STATE OF TENNESSEE DEPARTMENT OF TRANSPORTATION

INSTRUCTIONAL BULLETIN NO. 17-07

Regarding Revised Standard Drawings

Effective August 18th, 2017 letting (June 7th, 2017 Turn-in), the following Standard Drawings have been revised to add item numbers and/or a General Note: "See TDOT Roadway Design Guidelines Section 4-716.11 for line width and Section 4-716.30 for material type."

- REV. 9-1-05: REMOVED TYPE "C" WARNING LIGHTS FROM FLEXIBLE DRUMS IN TAPER.
- REV. 5-12-06: REPLACED VERTICAL PANEL WITH BARRIER RAIL DELINEATORS. ADDED GENERAL NOTES(G)&(H.)

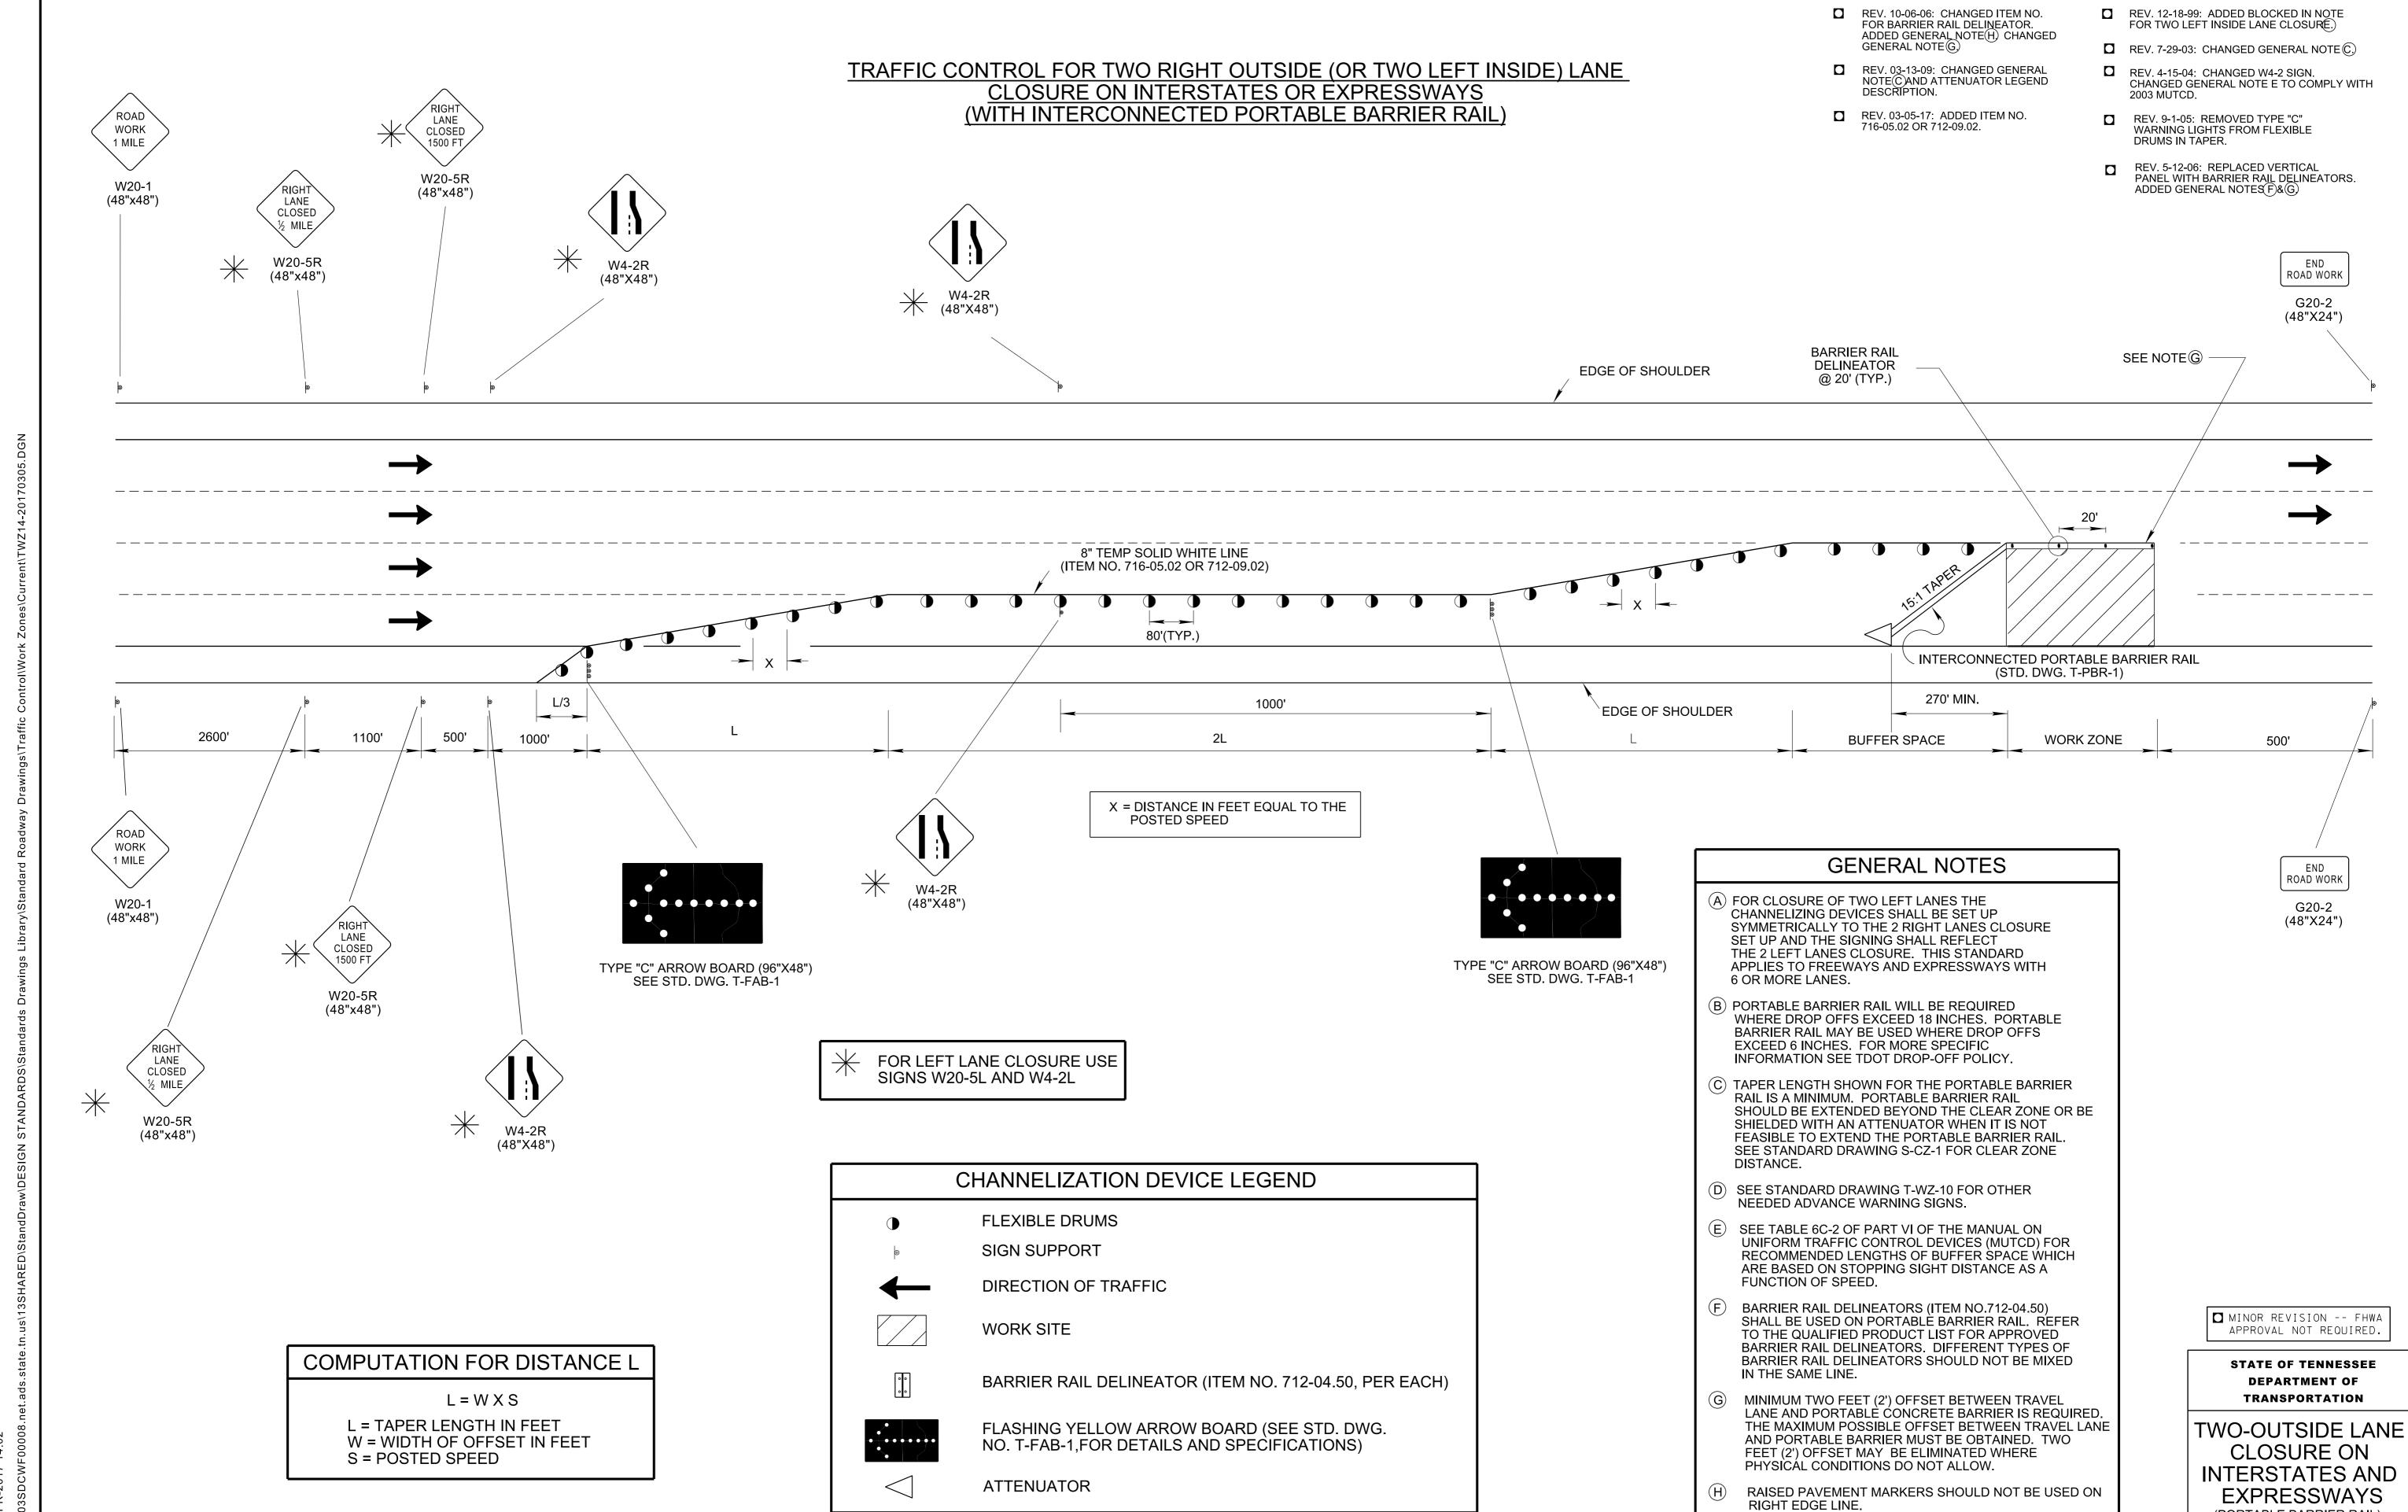
- REV. 10-06-06: CHANGED ITEM NO. FOR BARRIER RAIL DELINEATOR. ADDED GENERAL NOTE I. CHANGED GENERAL NOTE (E.)
- REV. 03-13-09: CHANGED GENERAL NOTE EAND ATTENUATOR LEGEND DESCRIPTION.
- REV. 03-05-17: ADDED ITEM NO. 716-05.02 OR 712-09.02.
- REV. 4-15-99: ADDED GENERAL NOTE(F)
- REV. 12-18-99: MODIFIED GENERAL NOTE(E)
- REV. 7-29-03: CHANGED GENERAL NOTE(E)

FREEWAYS AND **DIVIDED HIGHWAYS**

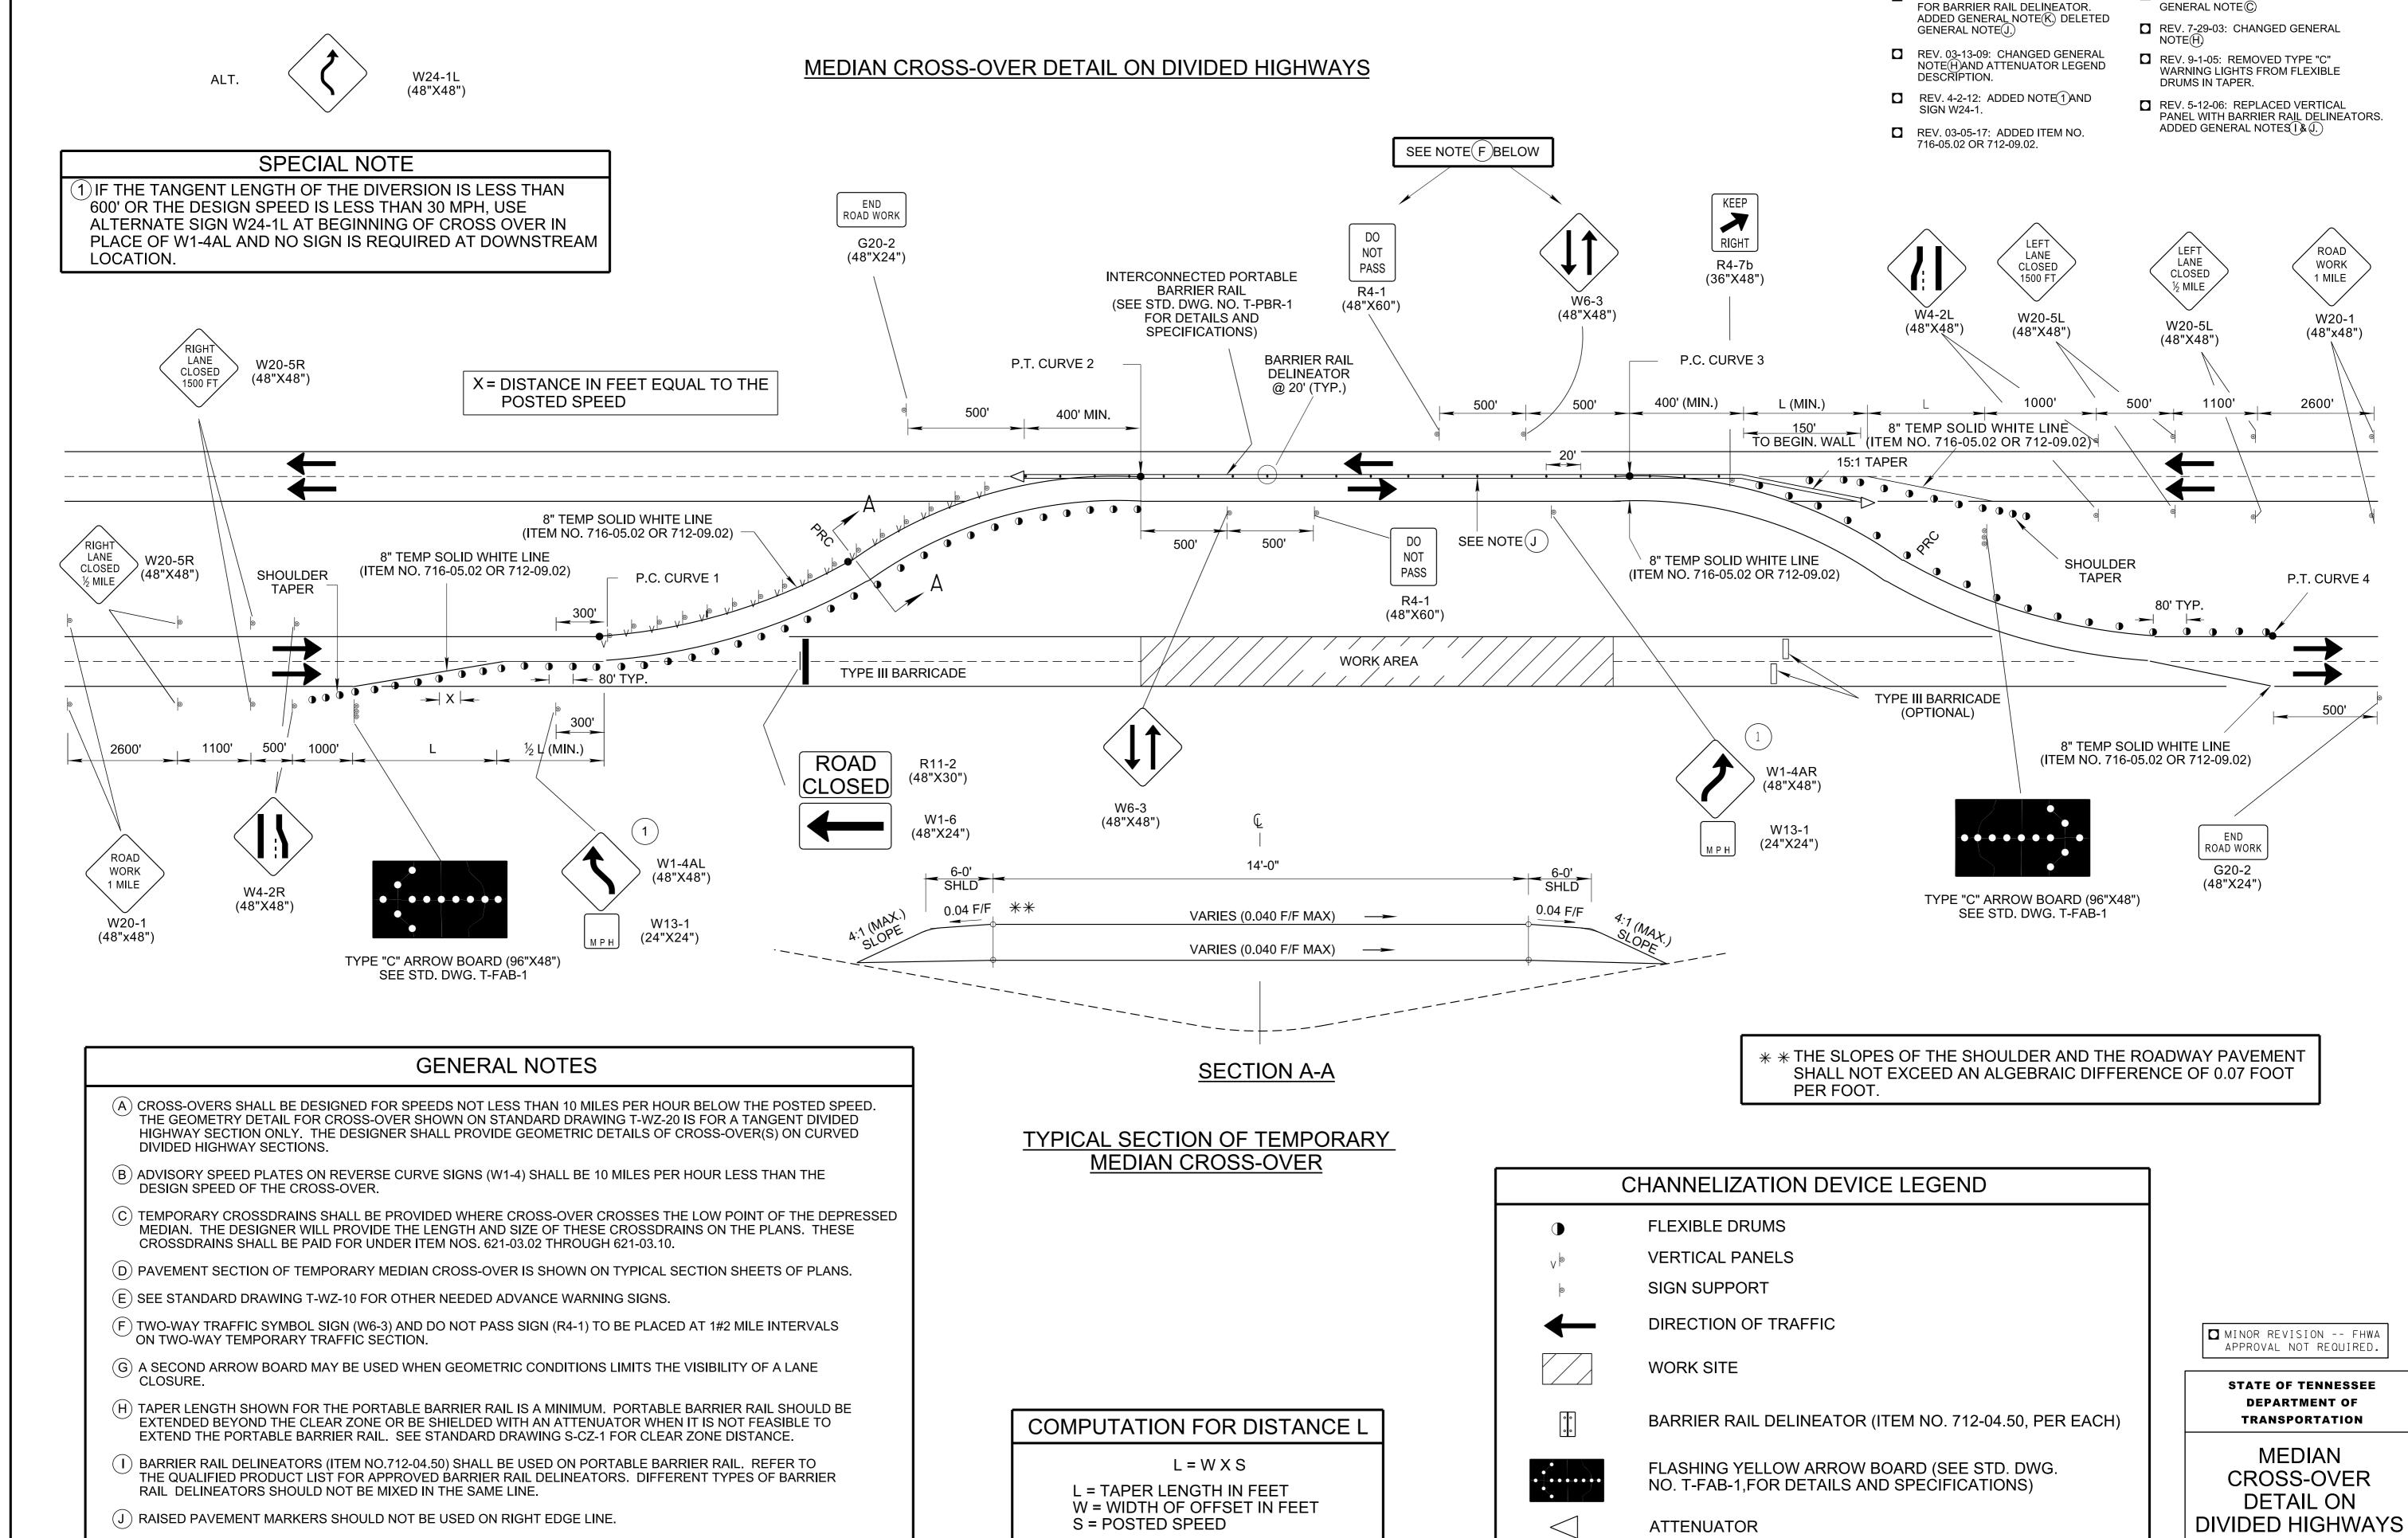
REV. 3-15-11: CHANGED SIGN (R2-5A) TO SIGN (W3-5) AND CHANGED FOOTNOTE(1) REVISED FLEXIBLE DRUM SPACING AND COMPUTION FOR DISTANCE. REMOVED SIGN R4-1

REV. 03-05-17: ADDED NOTE
